### Town of Thompson's Station Municipal Planning Commission Meeting Agenda June 28, 2016

### Thompson's Station Planning Commission Staff Report – Item 1 (PP 2016-004) June 28, 2016

### Thompson's Station Planning Commission Staff Report – Item 2 (File: SP 2016-003) June 28, 2016

### Thompson's Station Planning Commission Staff Report - Item 3 (File: FP 2016-002) June 28, 2016

R.O.W.C.T.

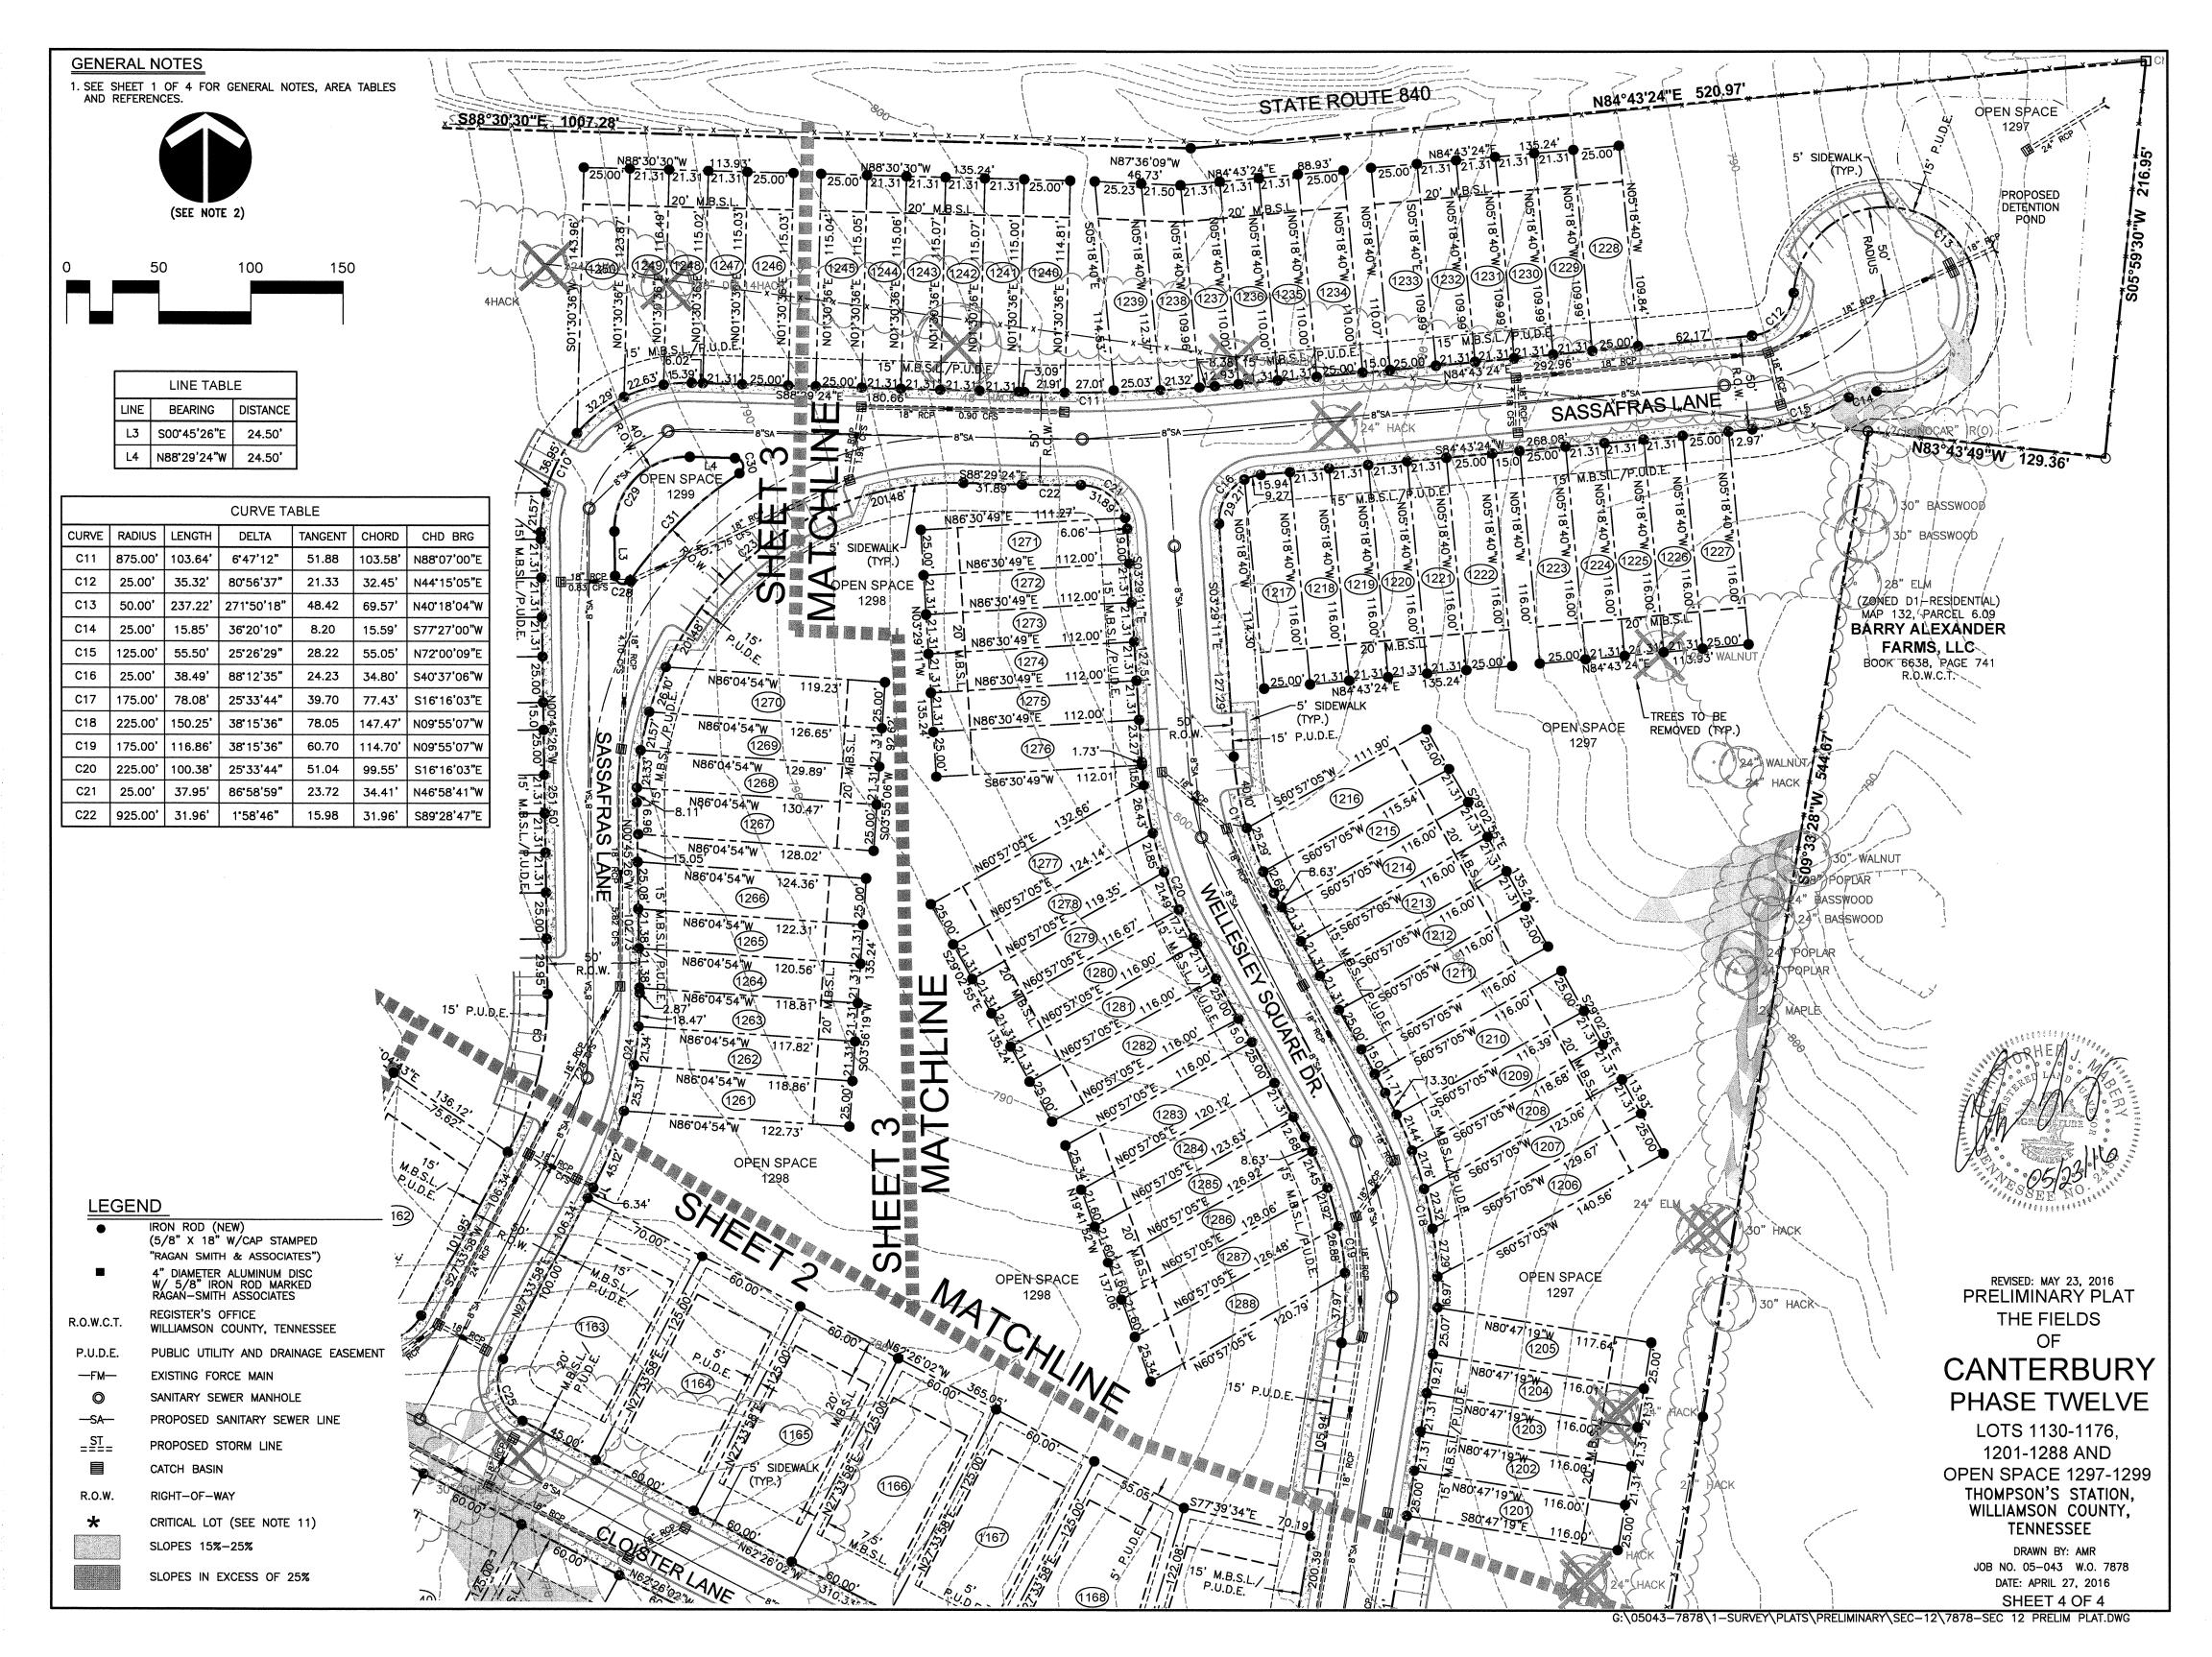
No development will occur on slopes exceeding 25%; however, several lots contain slopes between 15 and 25% and are critical lots due to these slopes. Lots 1130-1133, 1139-1140, 1142-1143, 1147-1150 and 1174 – 1175 are designated as critical lots on the plat. A mass grading plan will be reviewed with the construction plans and all critical lots will require engineered site plans to address all site specific issues when building permit is required.

Development of phase 12 will result in the removal of 45 trees for a total of 1,248 inches. The Land Development Ordinance requires the replacement of trees 24 inches and greater at a ratio of one and a half inches for every inch removed. Therefore, 1,872 inches of trees is required to be replaced on the site. The replacement plan includes one tree per each single-family lot for a total of 47 trees, one tree for each townhome lot for a total of 88 trees, 82 street trees and 326 "phase" trees. These 543 trees total 1,080 inches of the necessary replacement trees. The replacement plan also includes the existing trees located at the main entrance along Critz Lane, the berm and open space plantings in phase 10, and the amenity center trees for a total of 792 inches. The trees included in the replacement plan were trees planted by the developer and therefore, can be included to satisfy the requirements. Therefore, the replacement plan is consistent with the Land Development Ordinance.

While the preliminary plat provides an entitlement to move forward with the phase, construction plans are submitted, but review is not complete at this time. The construction documents provide all the necessary engineering for the development. During the review of the construction drawings, any engineering issues that are identified, including but not limited to grading, drainage, etc. will be required to be addressed adequately prior to approval. Therefore, any issues that arise during the construction plan review will be incumbent on the applicant to revise the preliminary plat accordingly to meet all engineering related standards.

Based on the project's consistency with the site development plan and the Town's Land Development Ordinance, Staff recommends that the Planning Commission approve the preliminary plat with the following contingencies:

- 1. Prior to the approval of construction plans, the applicant shall enter into a development agreement for the project.
- 2. Prior to the approval of construction plans, all applicable codes and regulations shall be addressed to the satisfaction of the Town Engineer.
- 3. Prior to the approval of construction plans, a drainage study shall be submitted to verify that drainage is managed adequately on site.
- 4. Prior to the approval of construction plans, a mass grading plan shall be submitted for review and approval.
- 5. During construction, the developer shall comply with Section 8.0 Recommendations, including 8.1 Earthwork, 8.2 Structural Fill, 8.3 Groundwater control and 8.4 Sinkhole Considerations from the geotechnical report dated June 1, 2016.
